March 8, 2023

Subject: City of Crystal design comments on the METRO Blue Line Extension

EXHIBIT A-2

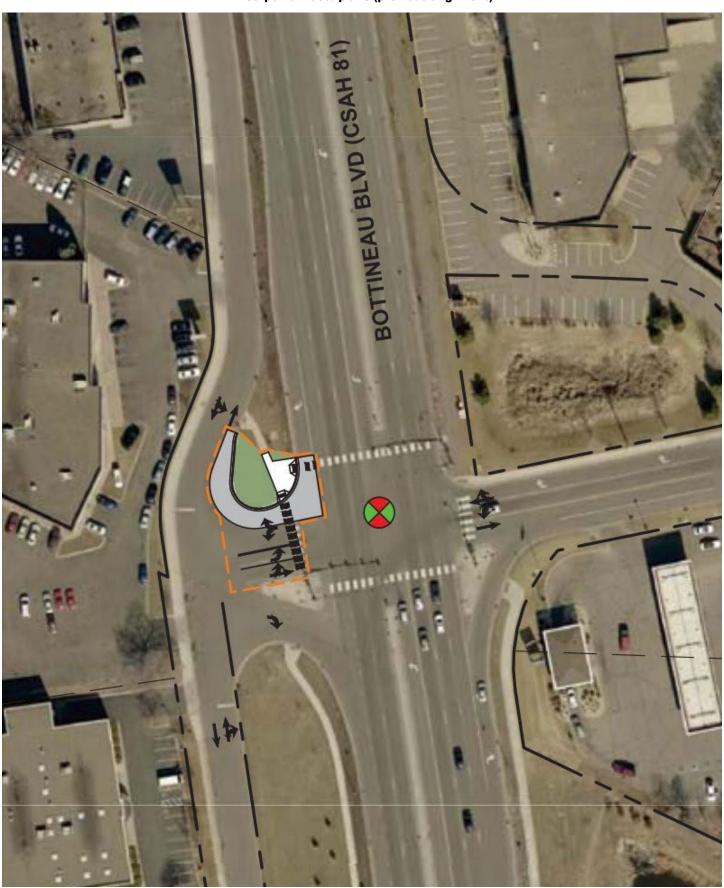
Include two left turn lanes from eastbound Wilshire Blvd. to northbound Bottineau Blvd. (Exhibit A-2).

- Due to traffic generated by vehicles leaving the park and ride facility and limited stacking space between Lakeland Ave. and Bottineau Blvd., two left turn lanes are needed from eastbound Wilshire Blvd. to northbound Bottineau Blvd.
- This was in the 90% plans for the previous alignment

EXHIBIT A-3

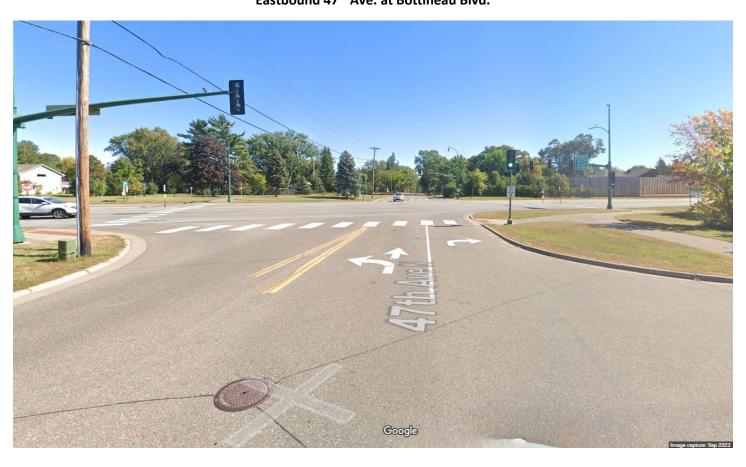
Optimize intersection performance with minor adjustments to signal and approach lanes (Exhibit A-3).

• For eastbound 47th Ave. turning right to go south on Bottineau Blvd., install a right-turn green arrow to overlap with the left-turn green arrow from northbound Bottineau Blvd. to

- westbound 47th Ave. This will increase the green time for the dominant movement on that approach with no penalty to the other approaches, except that U-turns from northbound Bottineau Boulevard to southbound Bottineau Blvd. / TH100 may need to be prohibited.
- For westbound 47th on the east side of Bottineau Blvd., due to limited stacking space, straighten the north side curb to create two lanes for the full distance between Lakeland Ave. and Bottineau Blvd., designate the right lane for straight movement or right turns, and designate the left lane only for left turns because that is the dominant movement on this approach.

EXHIBIT A-4

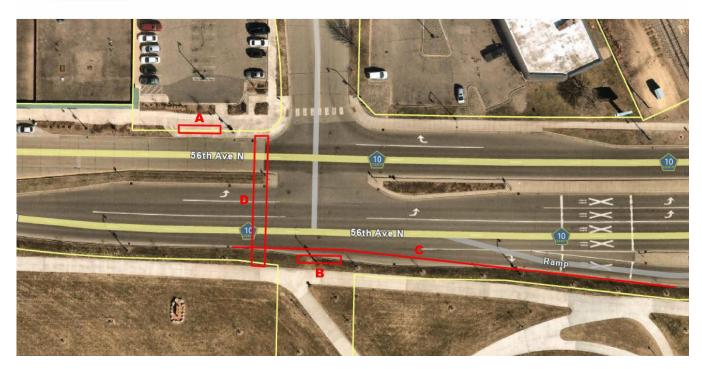
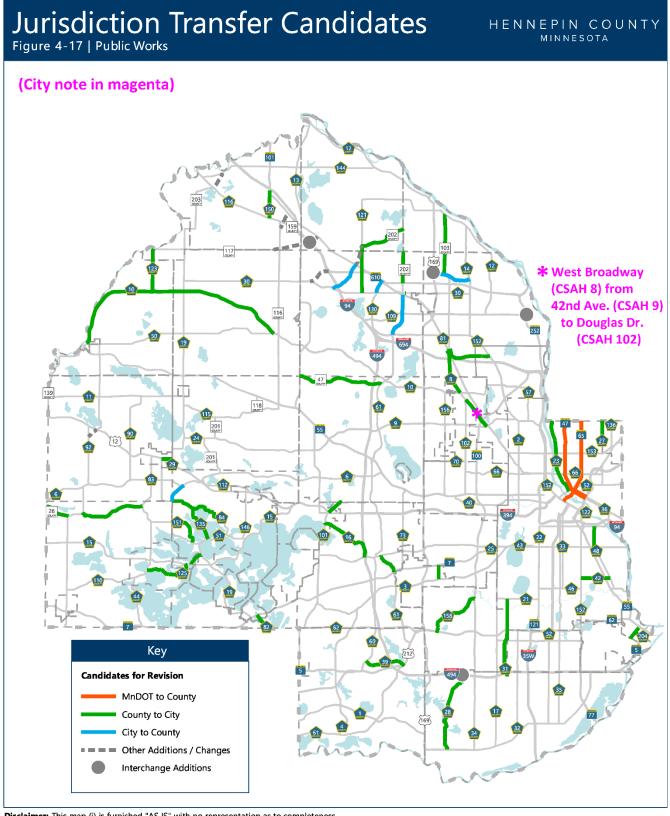
Add bus shelters on Bass Lake Road at Elmhurst, modify the south curb of Bass Lake Road, and construct an enhanced crosswalk including a median extension with a pedestrian refuge (Exhibit A-4).

- Shelters for east-west buses on Bass Lake Road are needed to improve the rider experience and facilitate transfers to and from LRT.
- Elmhurst is an existing, but unmarked, crosswalk that should become more prominent to discourage mid-block crossing. This should include an activatable beacon to warn drivers of pedestrians crossing so they have time to yield as required by law.
- These elements were in the 90% plans for the previous alignment.
- The city reserved space and aligned its trails/sidewalks to accommodate the planned bus shelters and crosswalk in its 2018 Bass Lake Road Streetscape and 2019-2020 Becker Park projects.

2040 forecast model - shift from Bottineau Blvd. to West Broadway

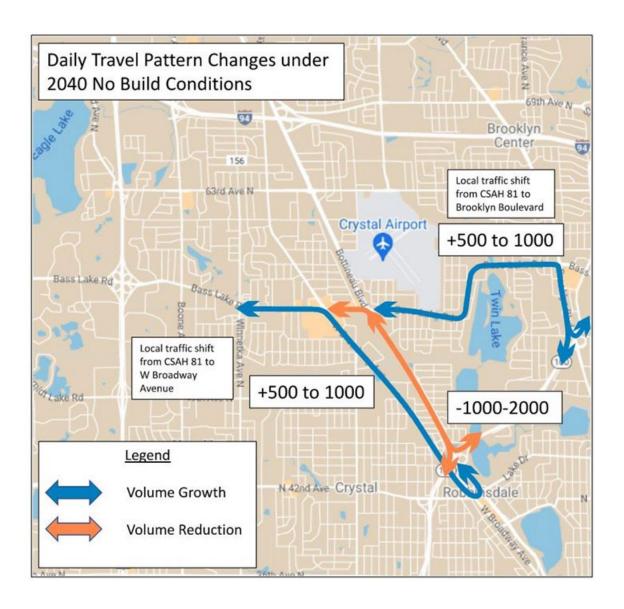
- The 2040 "no build" traffic forecast shows an estimated 1,000 vehicle per day diversion from Bottineau Blvd. to this segment of West Broadway (Exhibit A-5c).

- Additional diversion will likely occur due to the project and the lane reduction on Bottineau Blvd. West Broadway is the primary alternate route for vehicles avoiding congestion and delay on Bottineau Blvd.

EXHIBIT A-6a

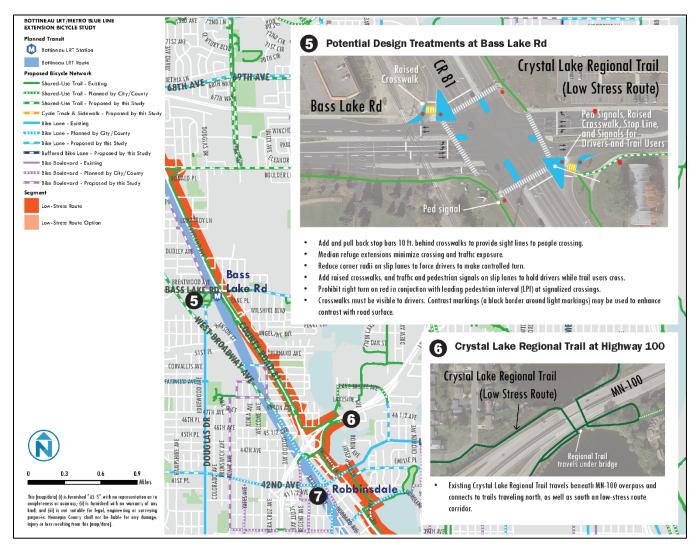
- Preserve the existing access route for pedestrians and cell tower maintenance vehicles from the southwesterly quadrant of the Bass Lake Road intersection to the proposed park and ride. (Exhibit A-6a.)
- Include at-grade pedestrian enhancements similar to those previously planned by Hennepin County in its 2016 Blue Line Extension Bicycle Study and construction project #1615 which did not proceed. (Exhibit A-6b.)
- Extend the off-street trail on the south side of Bass Lake Road from Bottineau Blvd. east to the vicinity of Xenia Ave. and transition to the existing on-street bike lanes in that area.
